Some Perspectives on the Proposed Cleanup & Abatement Order (CAO) from the IRP Manager

November 4, 2015 Barstow, CA

Lahontan Regional Water Quality Control Board

Prepared by IRP Manager

Q2, 2015 **Plume Shape**

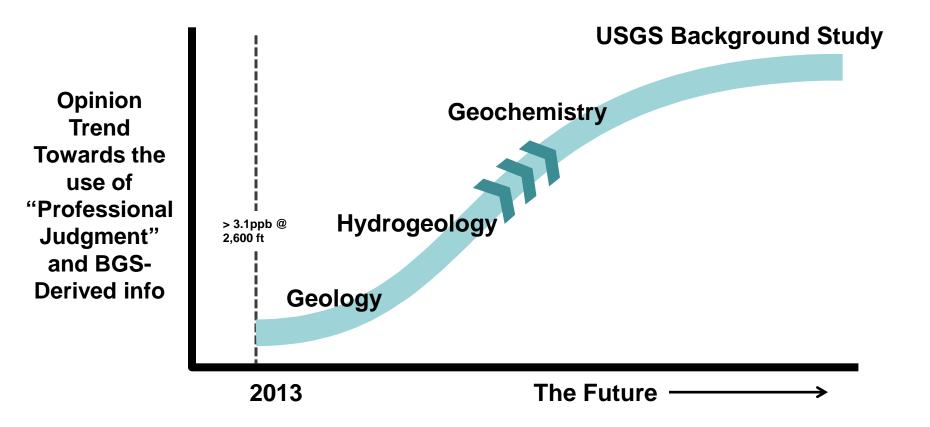
To emphasize, today, PG&E and the Water Board has more information available to contour rather than just joining dots,

such as; GW flow direction, modeling, geological cores, and new information flowing from USGS's BGS.

The Concern has been when to incorporate "new information" using "professional judgement."

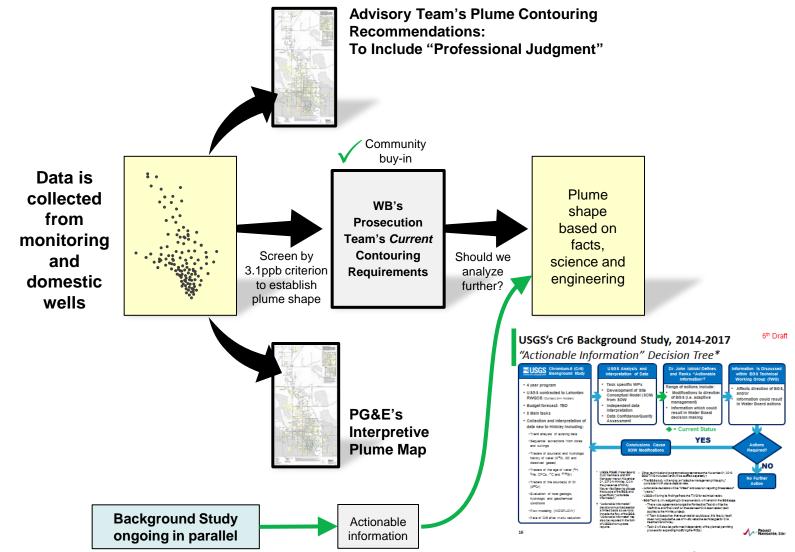
1. There Should be a *Trend Towards* the Use of "Professional Judgment" in Contouring the PG&E Cr6 Discharge

2. There Should be a *Trend Towards* the Use of "Professional Judgment" in Contouring the PG&E Cr6 Discharge

"Actionable Information" Decision Tree*

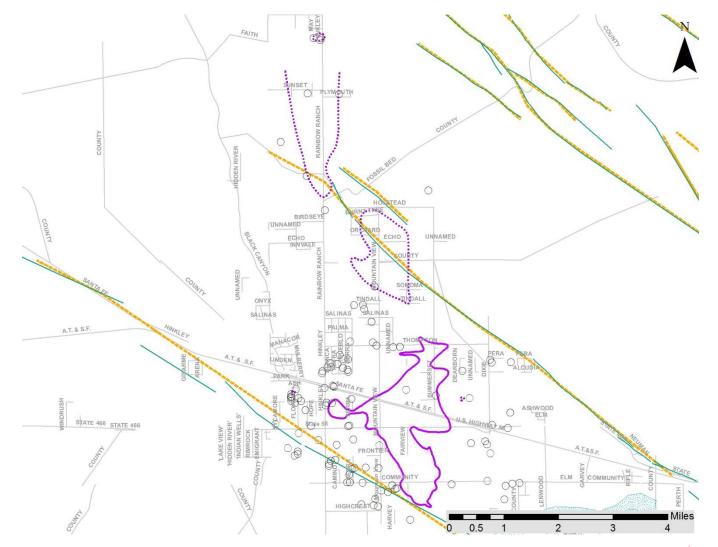
Dr. John Izbicki Defines and Ranks "Actionable Information"†

Range of actions include:

- Modifications to direction of BGS (i.e. adaptive management)
- Information which could result in Water Board decision making

Information is Discussed within BGS Technical **Working Group (TWG)**

- Affects direction of BGS. and/or
- Information could result in Water Board actions
